DEVELOPMENT REVIEW COMMITTEE

1. Taco Bell Site Development Plan Review

A site plan review of a proposed Taco Bell Restaurant at 60 N 400 E

SANTAQUIN TACO BELL
 60 N 400 E ST.
 SANTAQUIN, UT 84655
 SITE DEVELOPMENT PLANS
 COVER SHEET

DRAWING NO.
C1

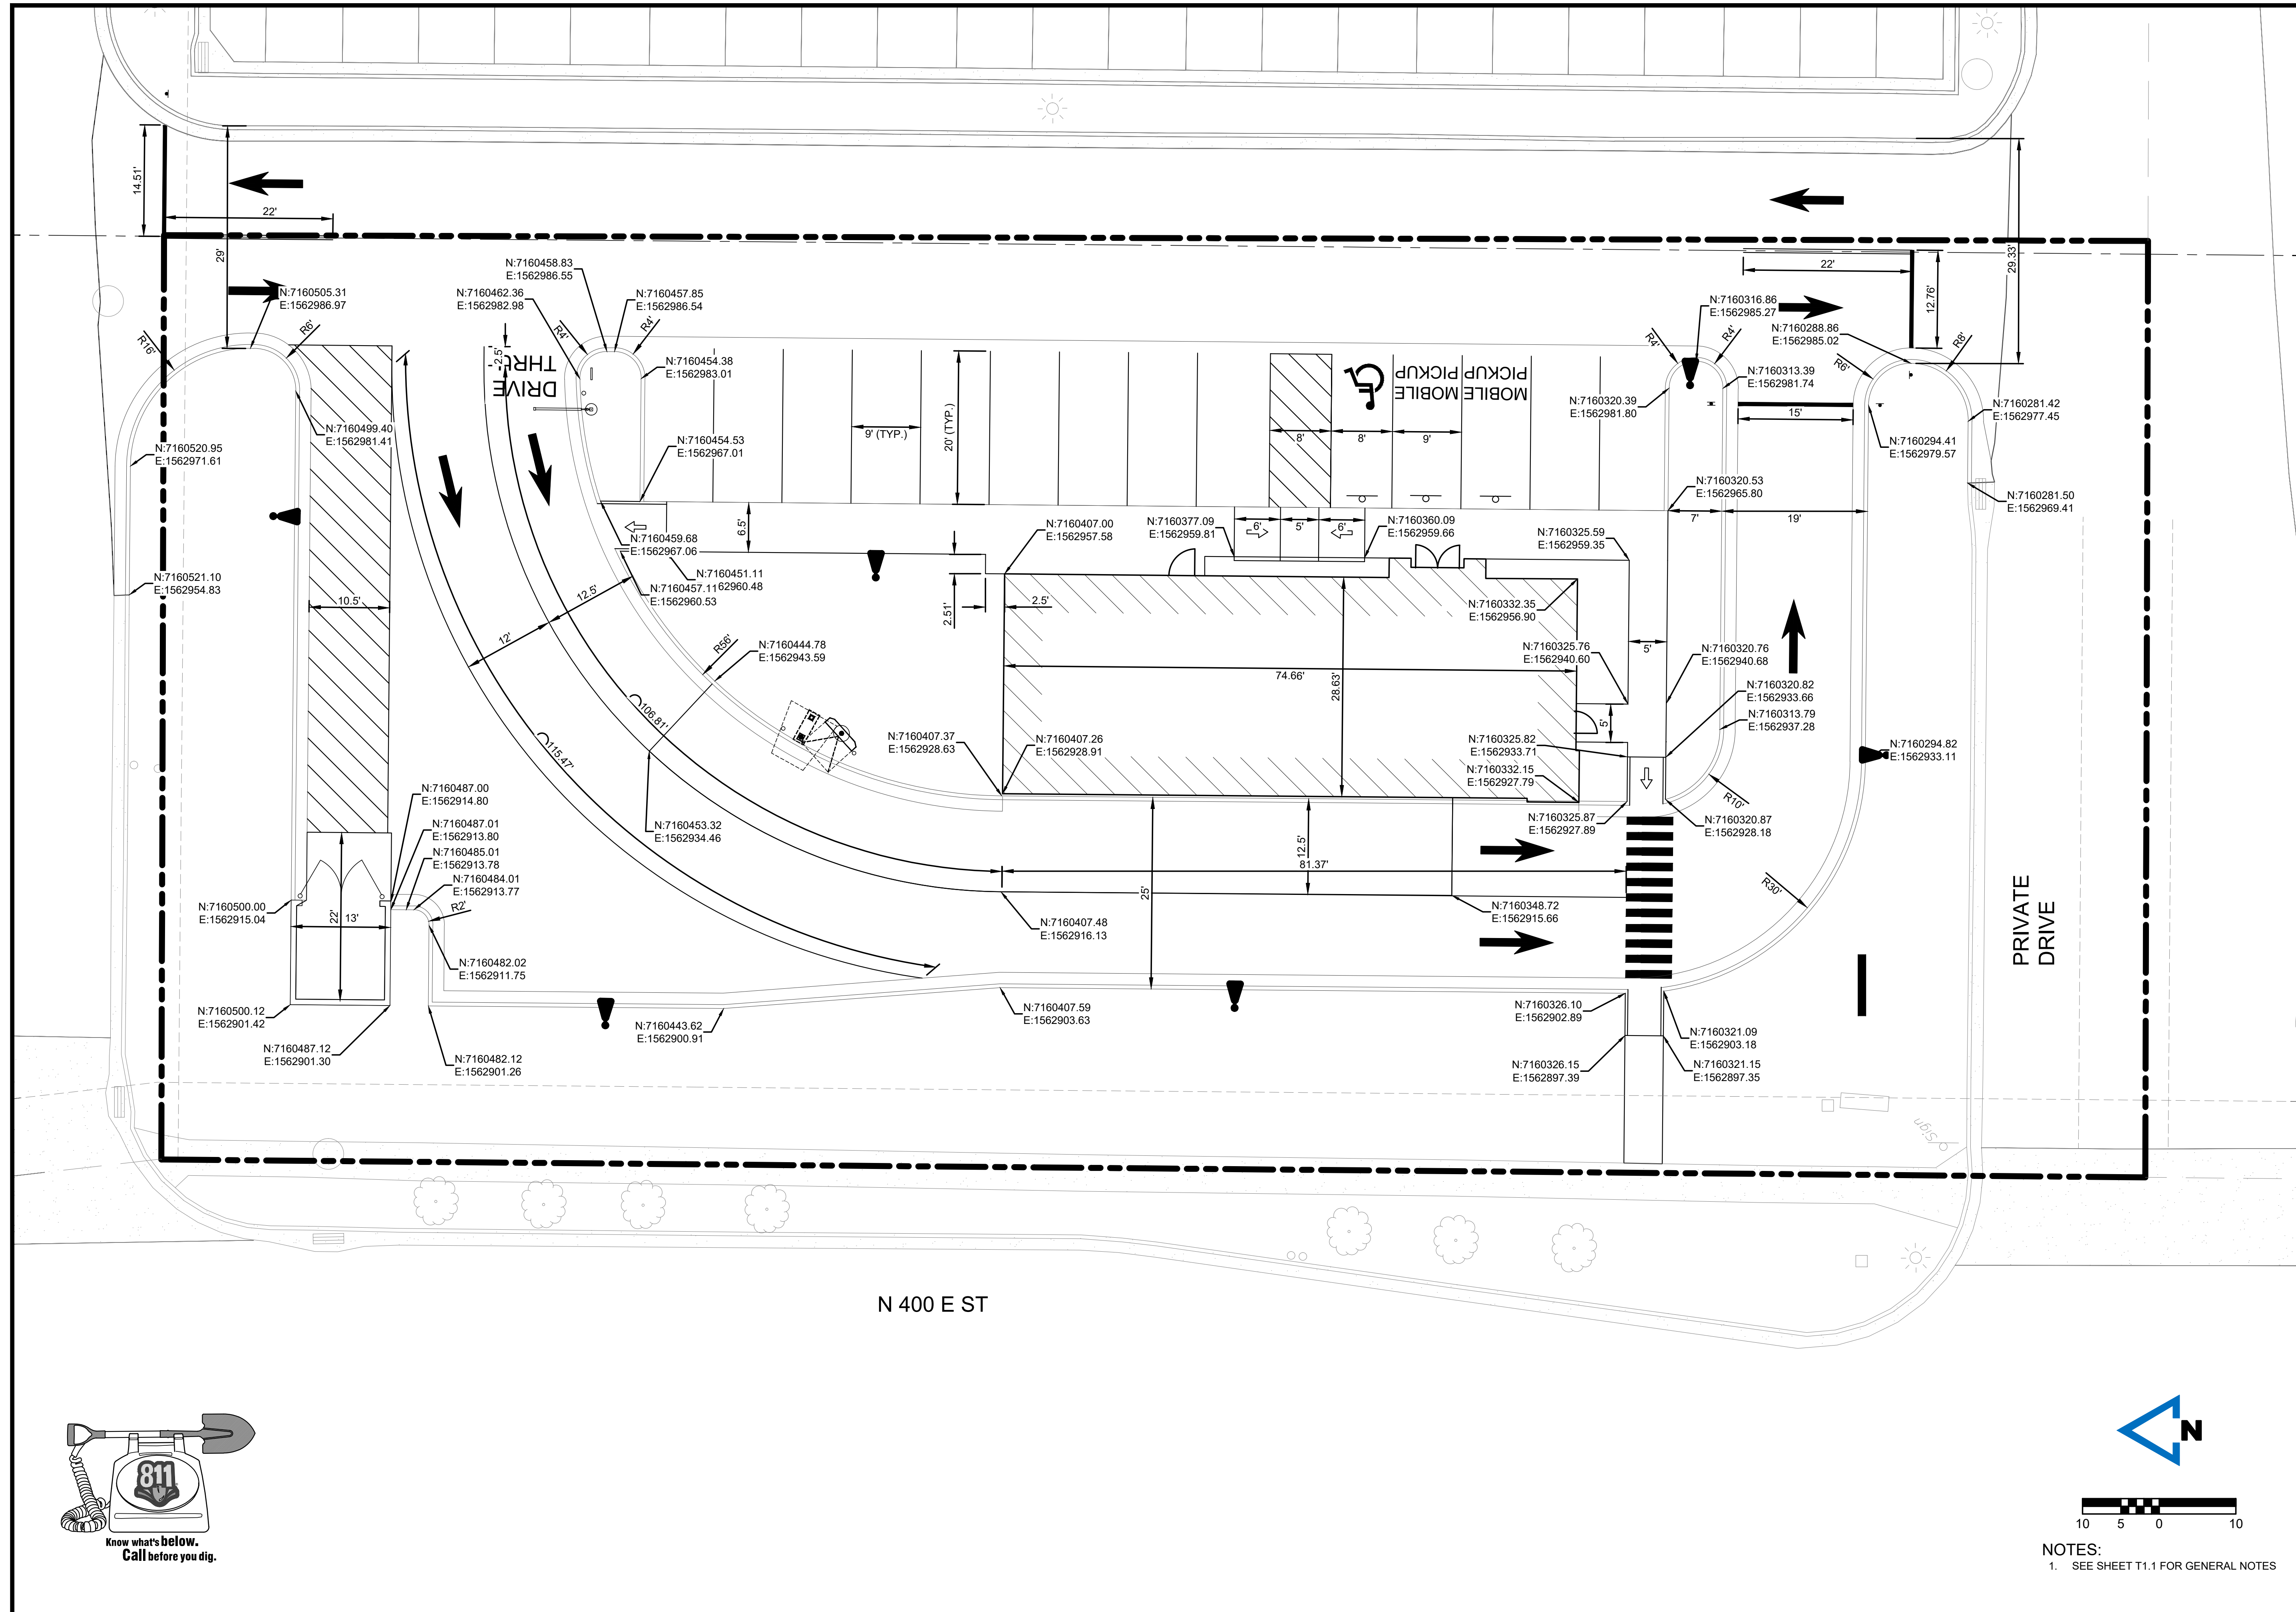
Wall asked whether North Orchard Lane is a city or private road. Lundell responded that, aside from 400 East, all roads within the development should be assumed private. Wall stated that Public Safety would prefer a stop sign before entering North Orchard Lane, though the City could not require it on private property. Lundell confirmed that stop signs and "No Entry" signs are already shown on the site plan.

Beagley asked for clarification regarding the two lanes shown on the plans, specifically whether both were intended as drive-through ordering lanes. The applicant clarified that one lane functions as a bypass or slip lane to allow vehicles to exit or pass through the drive-through queue if needed.

DRAWING NO.
C4

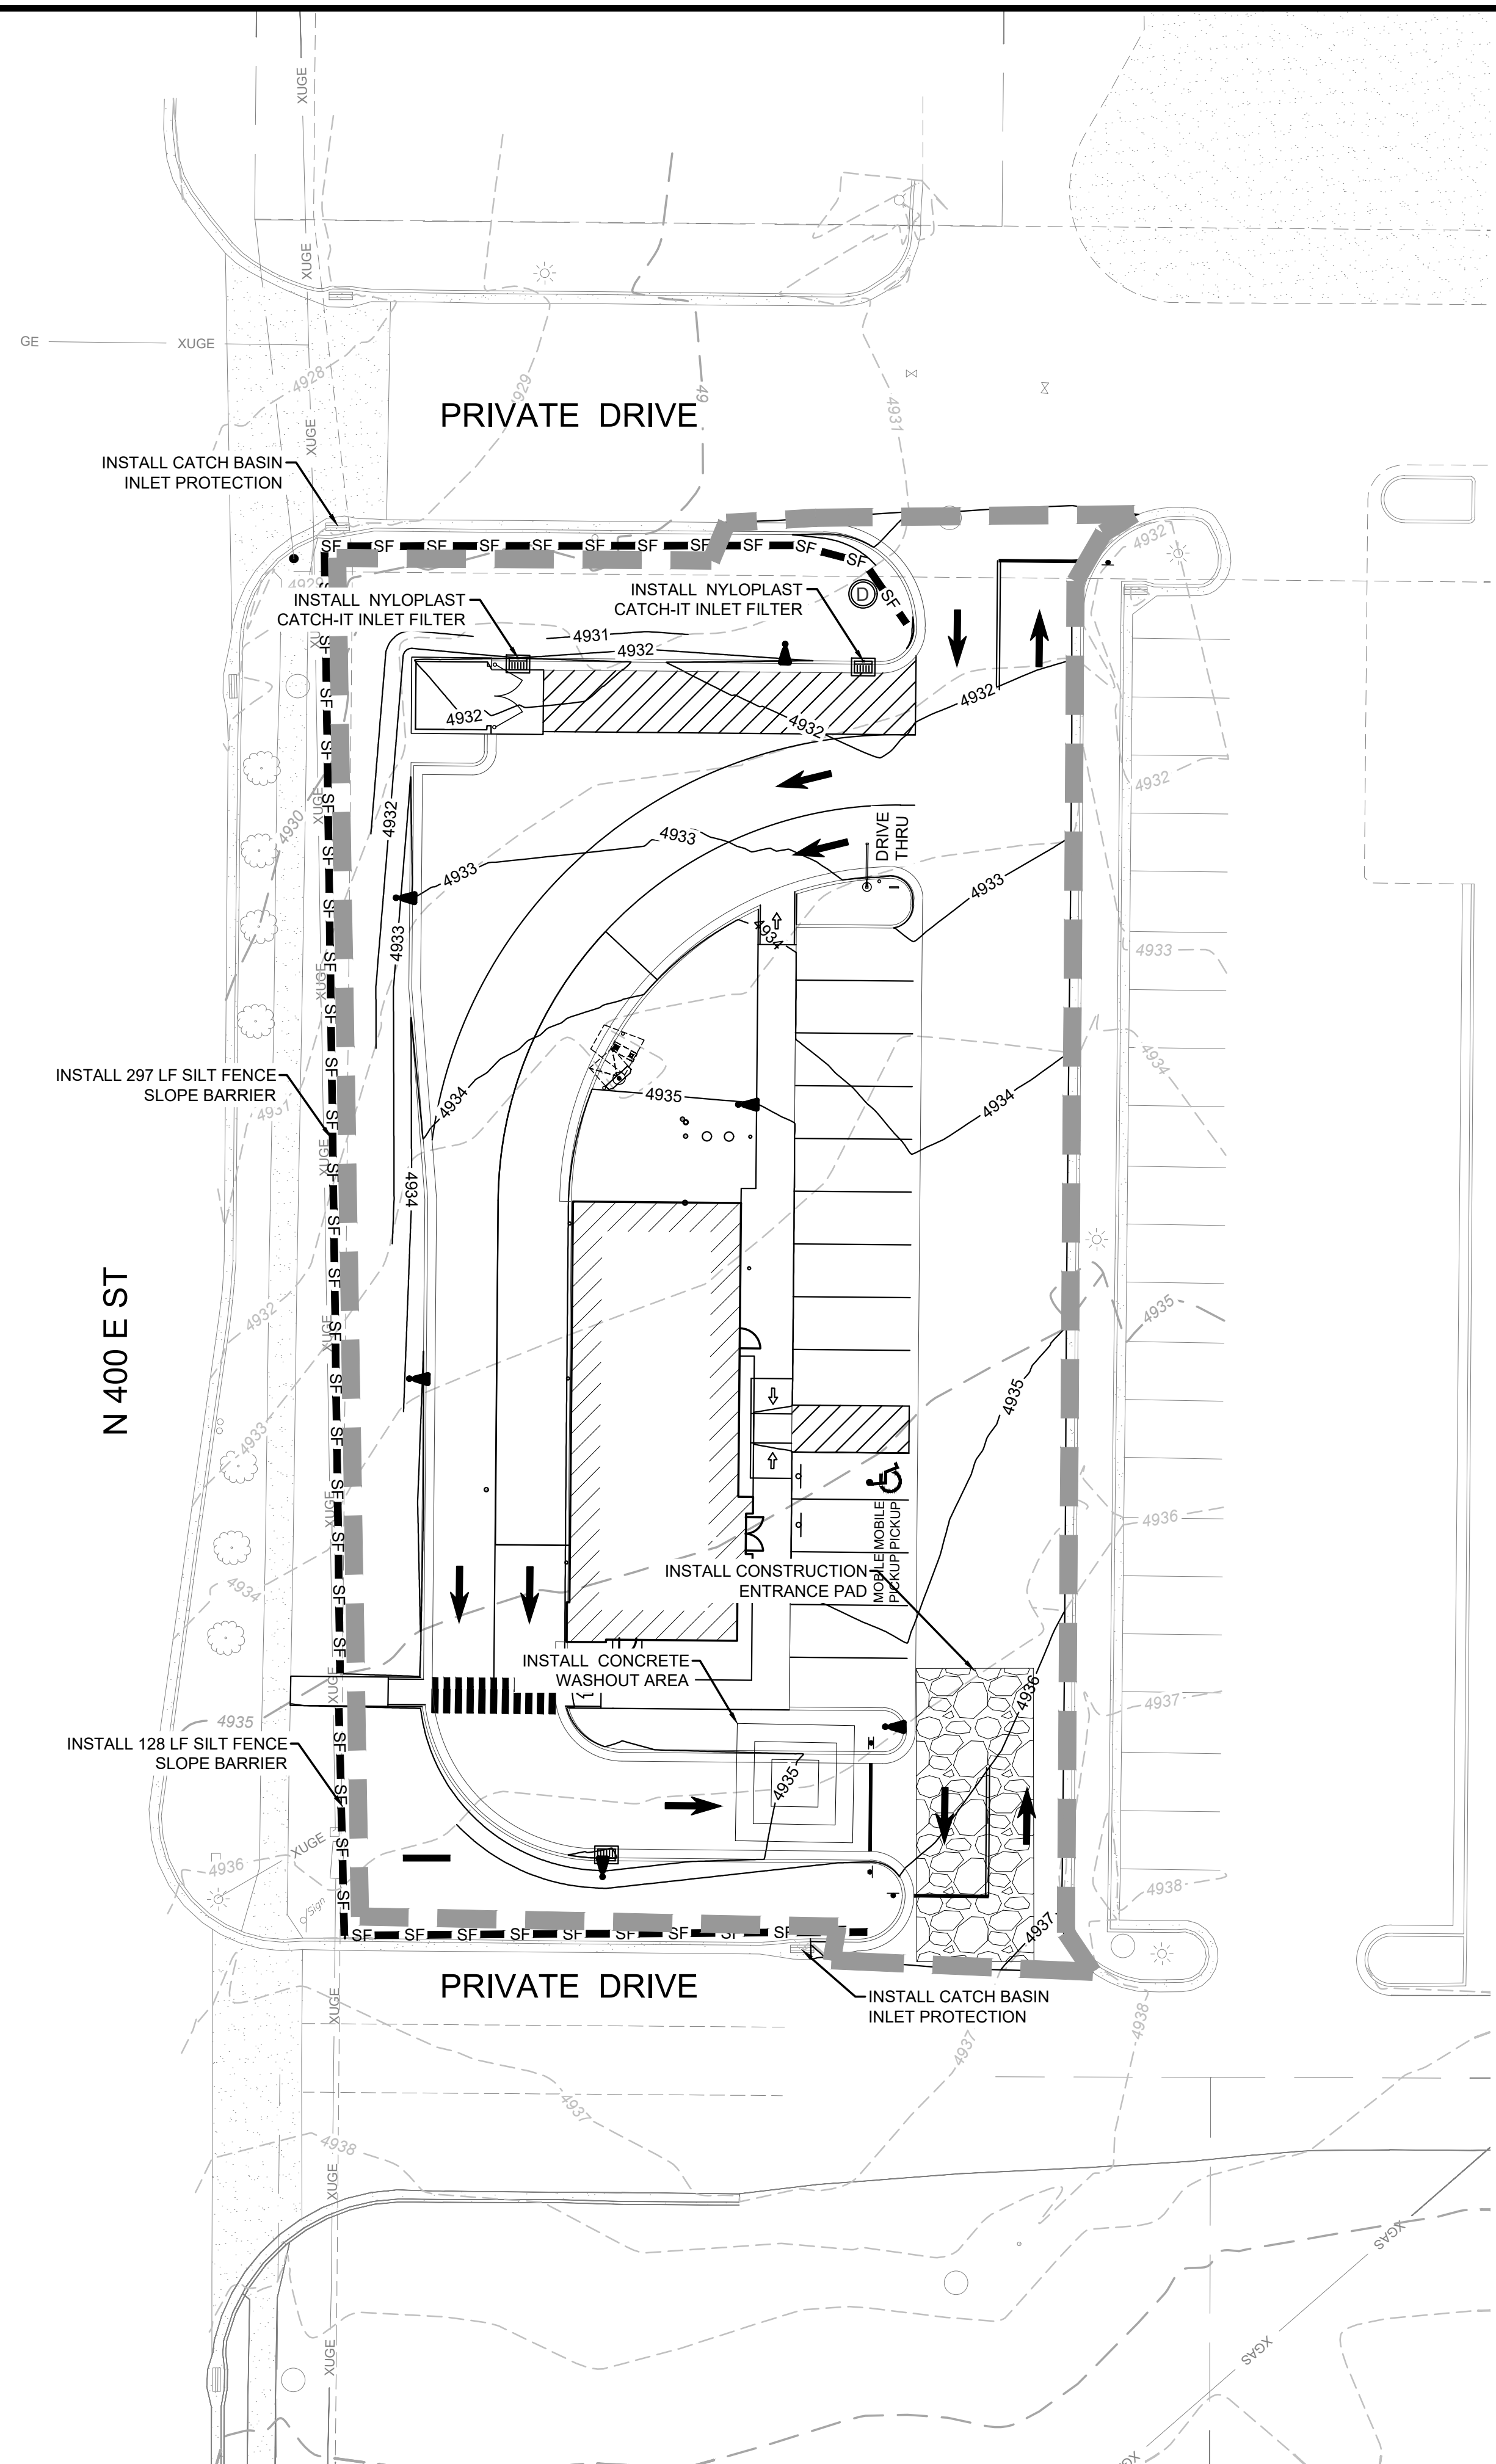
Lundell noted that the plans currently show a 1½-inch copper service line and suggested that a poly line may be a better option for installation. Callaway agreed and the applicant indicated that they would likely proceed with poly pipe instead of copper.

LANDSCAPE PLAN

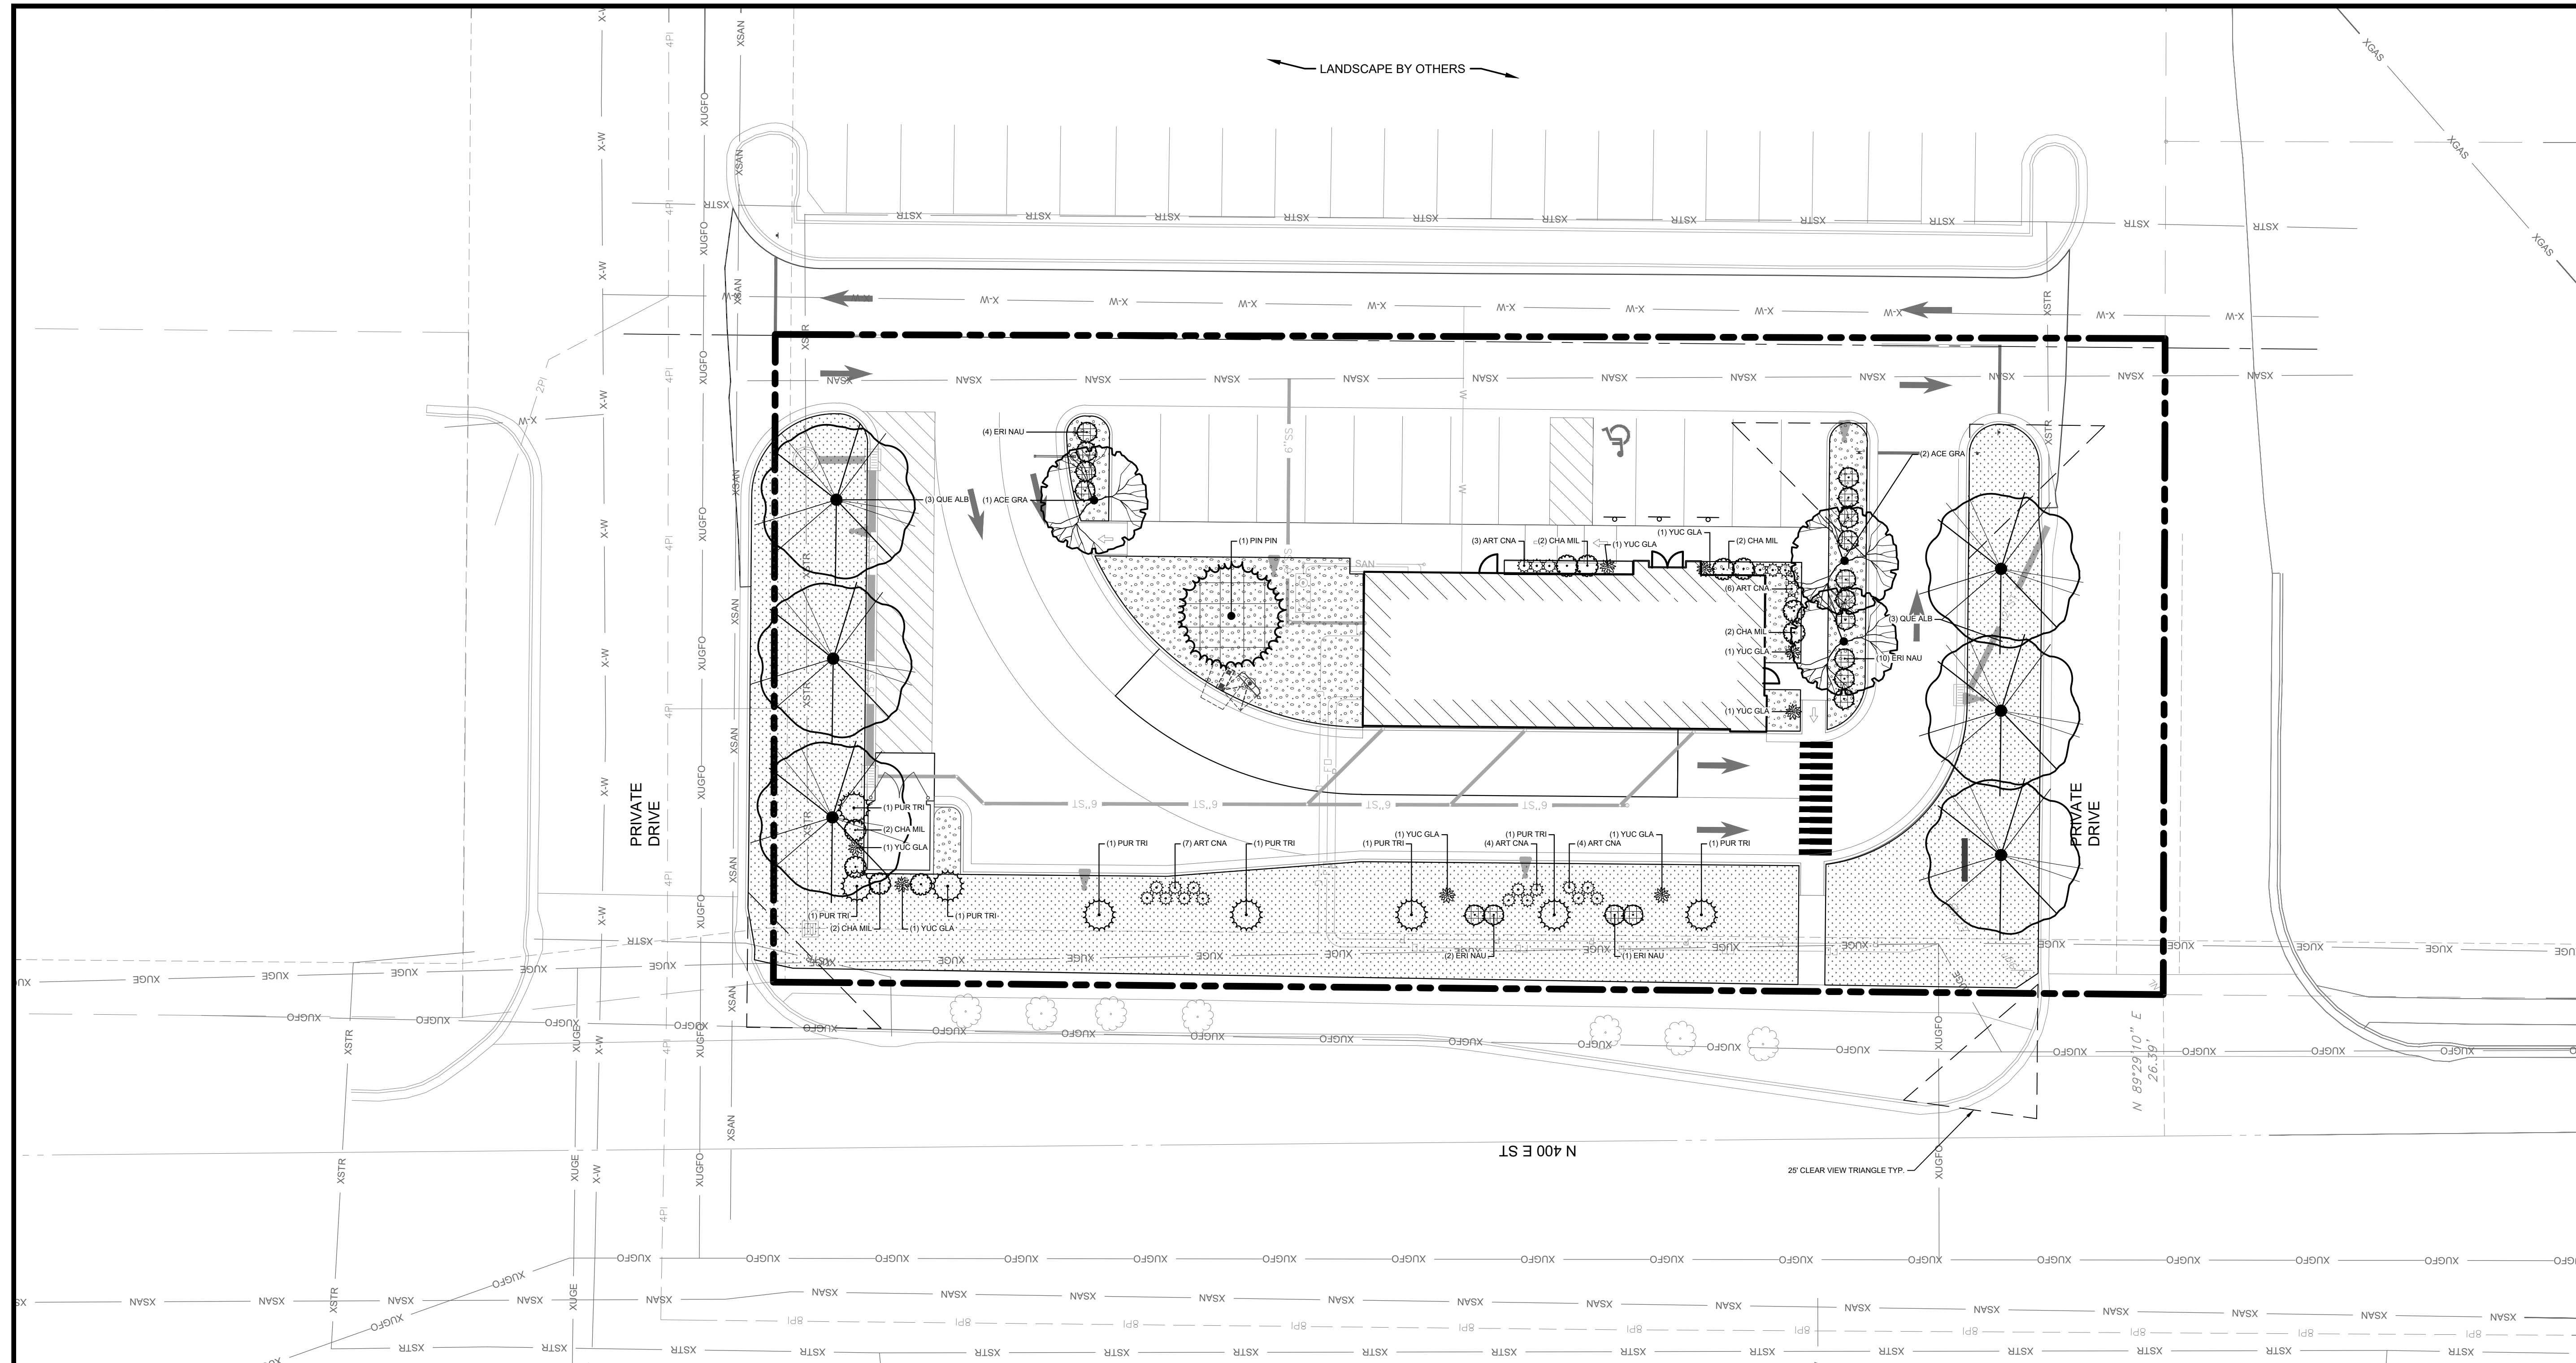
Wall also raised concerns regarding two trees shown on the landscape plan near the drive-through exit, noting they could obstruct visibility for vehicles exiting the site. He referenced a similar issue near Little Caesars, where a tree was later removed due to visibility concerns, and recommended relocating the trees. Lundell stated the landscaping could be adjusted while still meeting tree requirements. Beagley suggested relocating the two trees farther west, away from North Orchard Lane and the curve along 400 East. Beagley also requested that the street names be removed from the site plan to avoid confusion and suggested labeling the roadway as "Private Access" or simply "Access," noting that the area is private property providing access to the surrounding buildings.

Elmer explained that the landscape plan should identify the percentage of each landscaping material used, as City code limits decorative materials such as crushed rock to no more than 50% of the landscaped area. Additional live plant material may therefore be required. Beagley clarified that the added plantings do not necessarily need to be trees and could include shrubs or similar vegetation.
